Project Title: MCT Frontage Road Property Building Permit #: _____ City Drainage #: EMD060

RE: **MCT Frontage Road Property**
Grading and Drainage Plan
Engineer's Stamp Date 7-21-16 (File:E17D060)

Re: MCT Frontage Road Property
Revised Engineers stamp date 7-26-2016- (EI7D060)

From: Carrillo, Abiel X.
Sent: Friday, July 22, 2016 11:33 AM
To: 'Kelly Klein'
Subject: MCT - E17D060 - Stamp Date 6-30-2016

1996

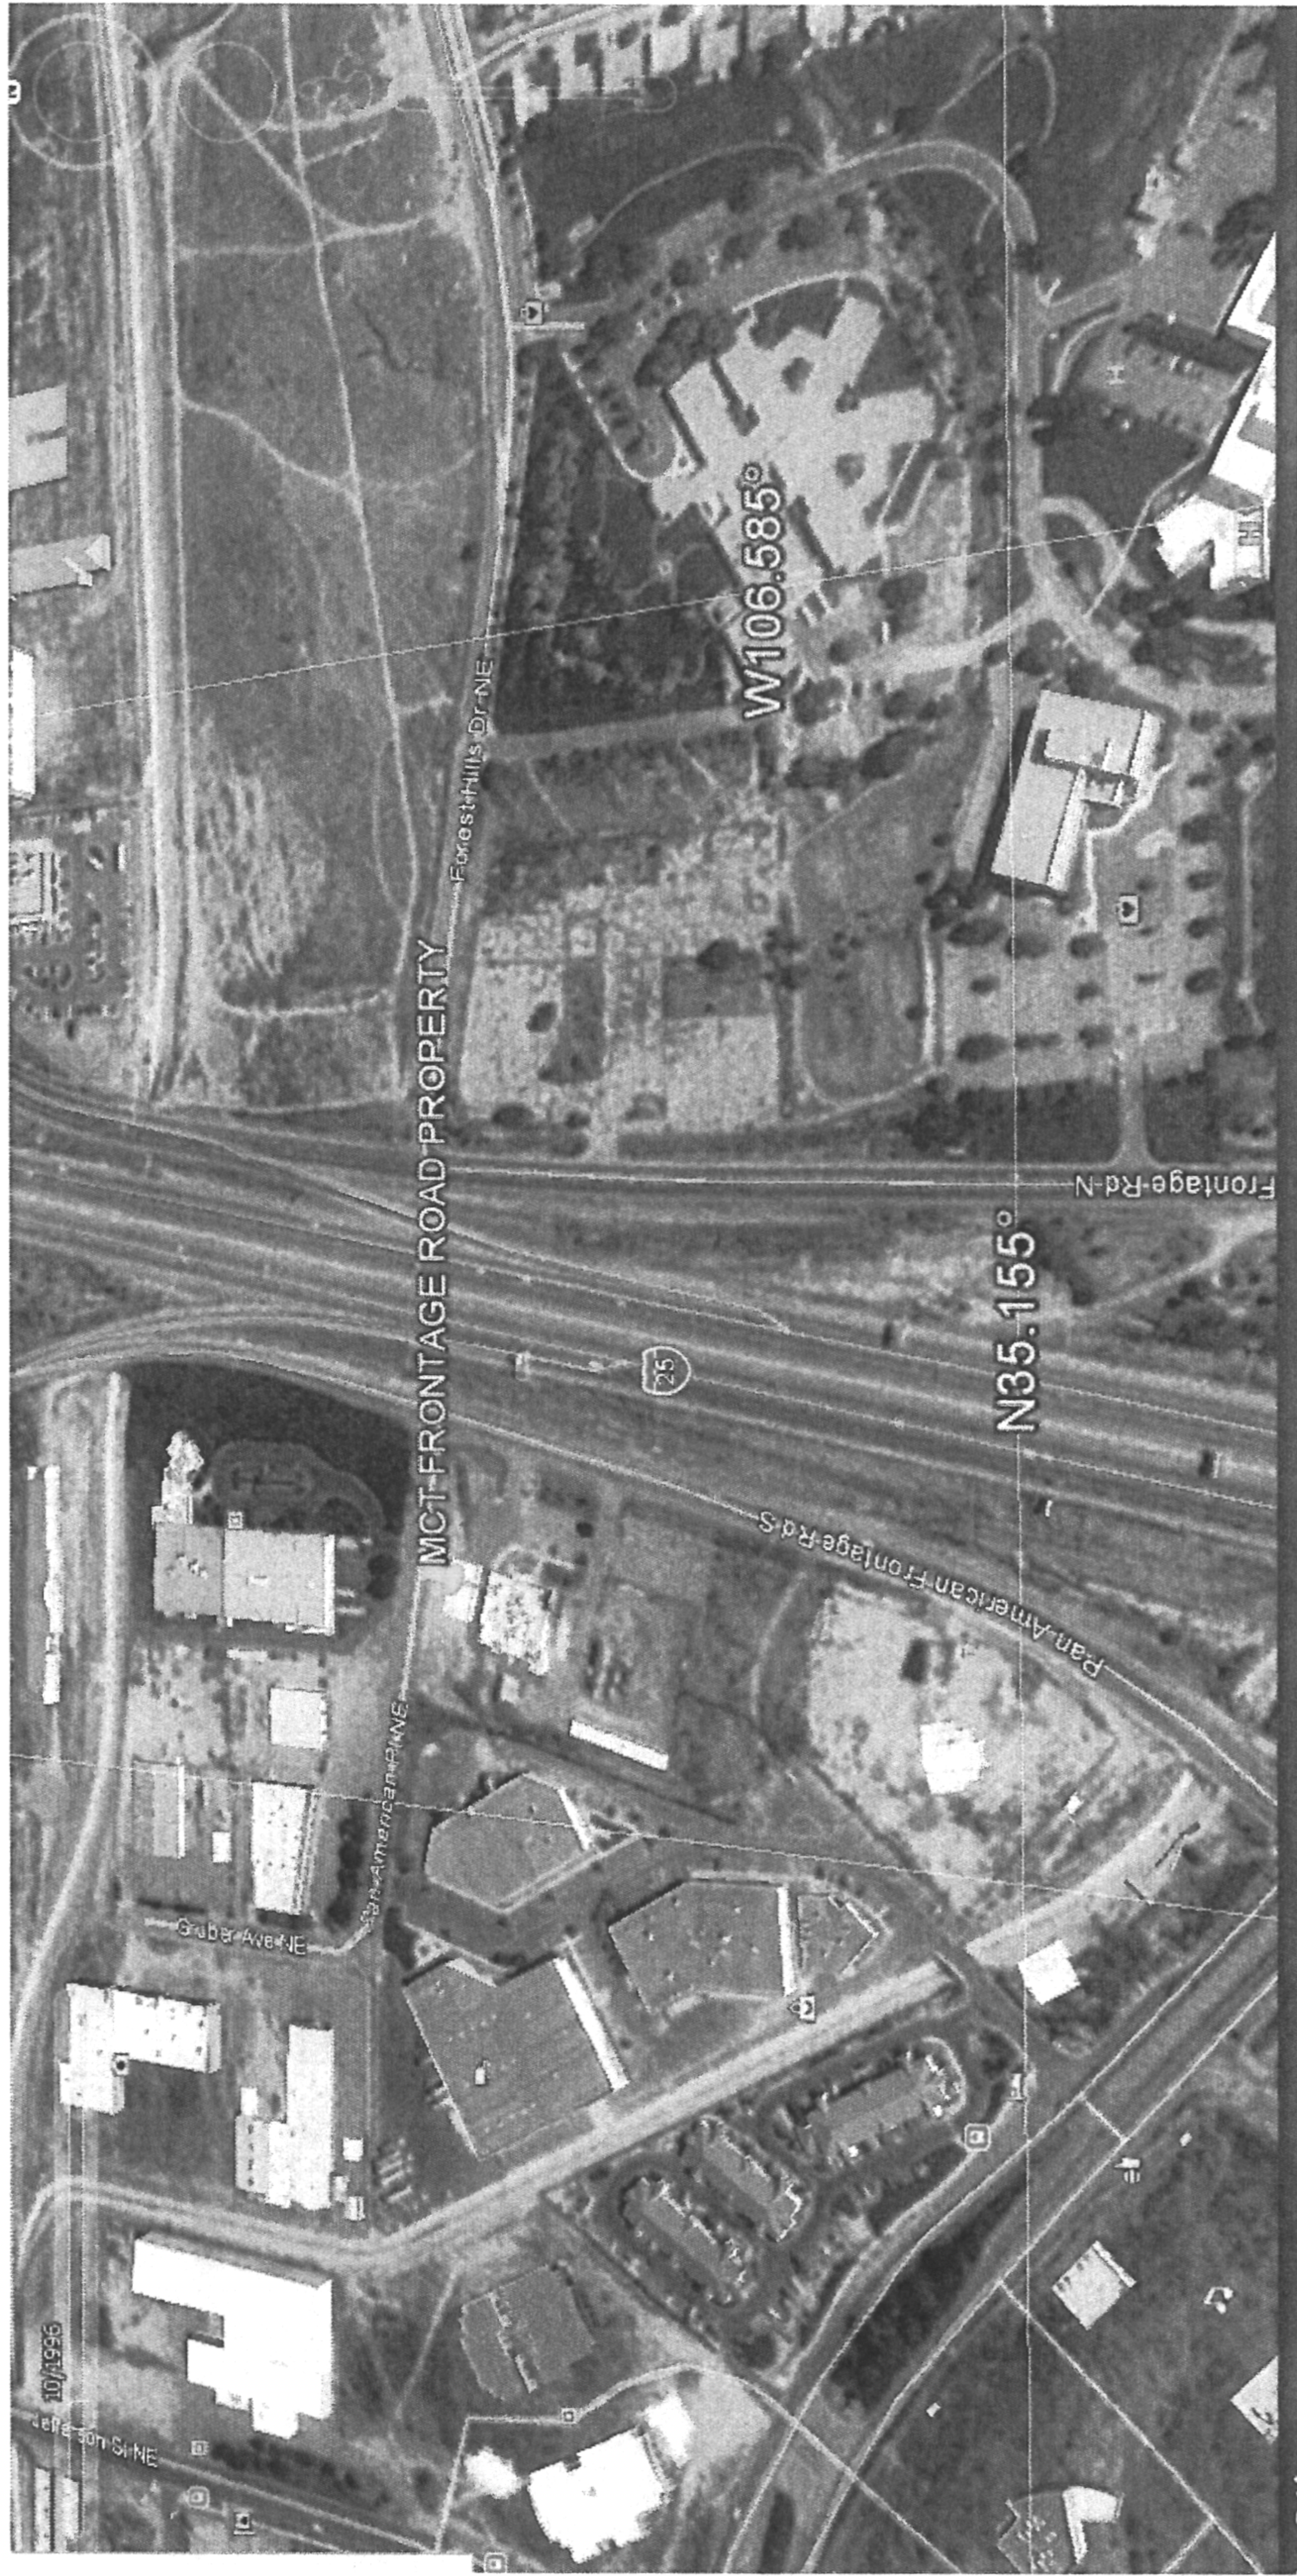
1. **The plan proposes to discharge into the adjacent property to the southwest....."**
In absence of a full drainage report for the adjacent property, we looked at existing and historical conditions. I attached aerial photographs to this letter to show the property from 1996 and 1999. These photographs were taken from Google Earth and the RGIS ortho photography. From these photographs, it is determined that the drainage paths for the area are consistent with the assumptions on the projects site's drainage plan. In addition, there are "offsite" flows from the NMDOT ROW on the east boundary that enter the site. To calculate the historic flows, I inserted the pictures into AutoCAD to get area calculations for the different land treatment types and used AHYMO to determine the flows. The historic flows are summarized on the revised plan and include the offsite flows from the NMDOT ROW.
